40 CFR Part 63

National Emission Standards for Hazardous Air Pollutants for Source Categories: Organic Hazardous Air Pollutants From the Synthetic Organic Chemical Manufacturing Industry and Other Processes Subject to the Negotiated Regulation for Equipment Leaks

ACTION: Proposed rule; amendments.

Figure 1. ALTERNATIVE EXPERIMENTAL METHODS FOR DETERMINING THE FRACTION OF ORGANIC COMPOUND BIODEGRADED (Fbio) IN A BIOLOGICAL TREATMENT UNIT

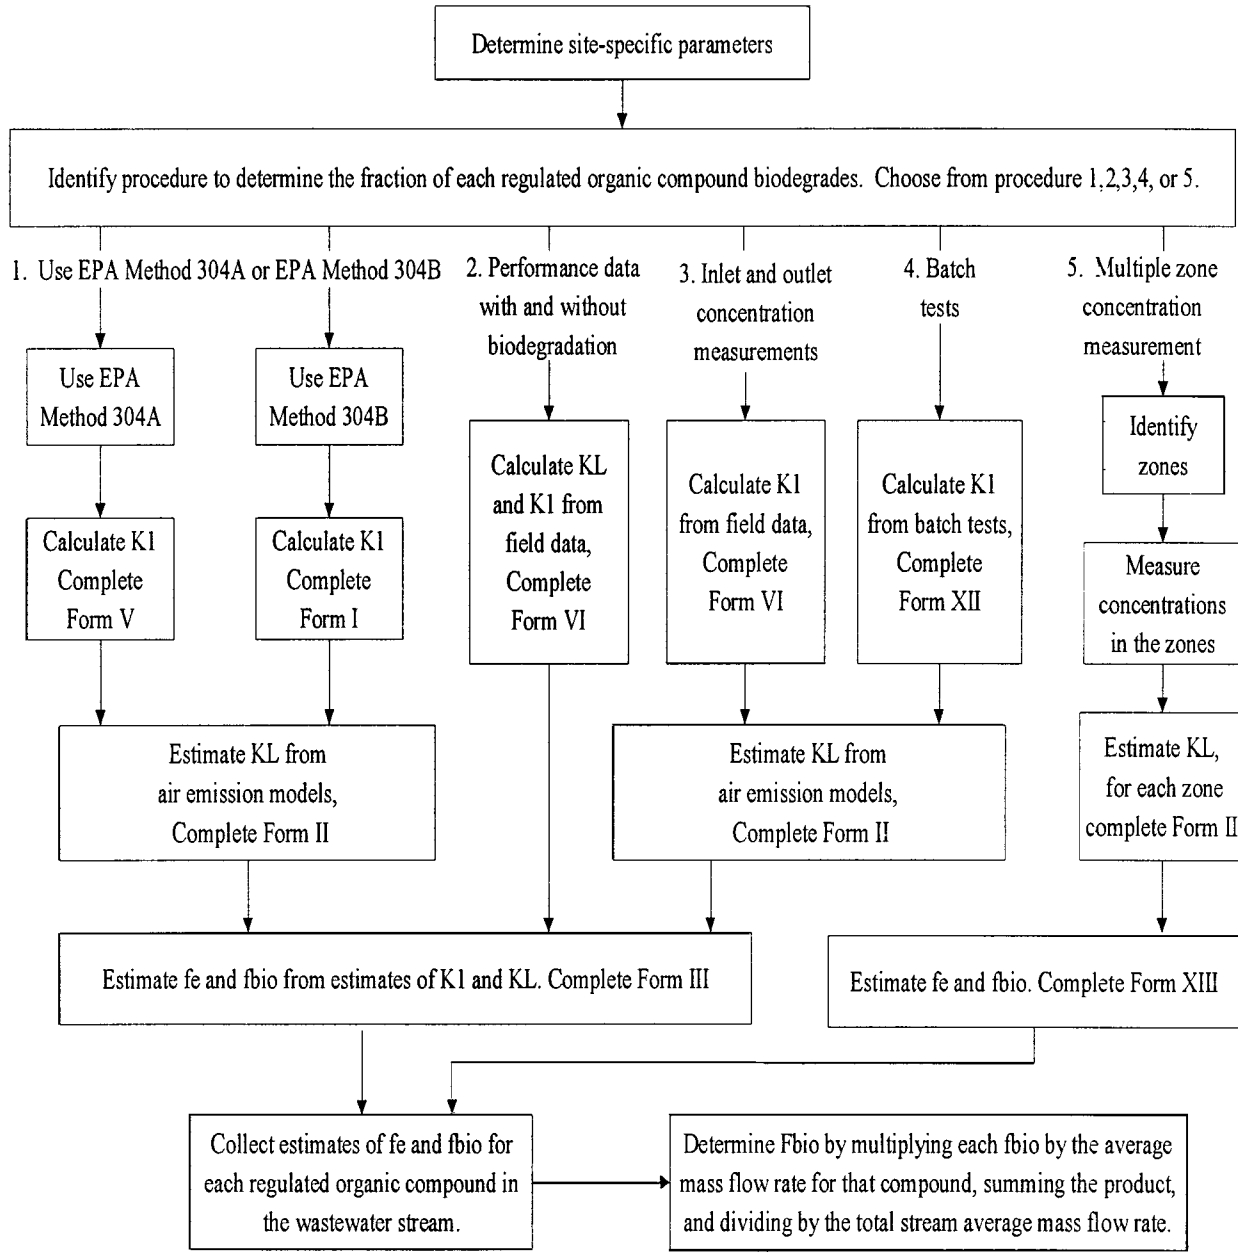
- 23. Appendix C to part 63 is amended by:
 - a. Revising the third paragraph in section I;
 - b. Revising the introductory text to section III;
 - c. In section III.D.1, revising Eqn App.C–4 and the paragraph preceding it;
 - d. In section III.D.2, revising Eqn App.C–6 and the paragraph preceding it;
 - e. Adding section III.E;
 - f. Adding references 7 and 8 to the References section;
 - g. Revising Figure 1;
 - h. Adding Form XIII.
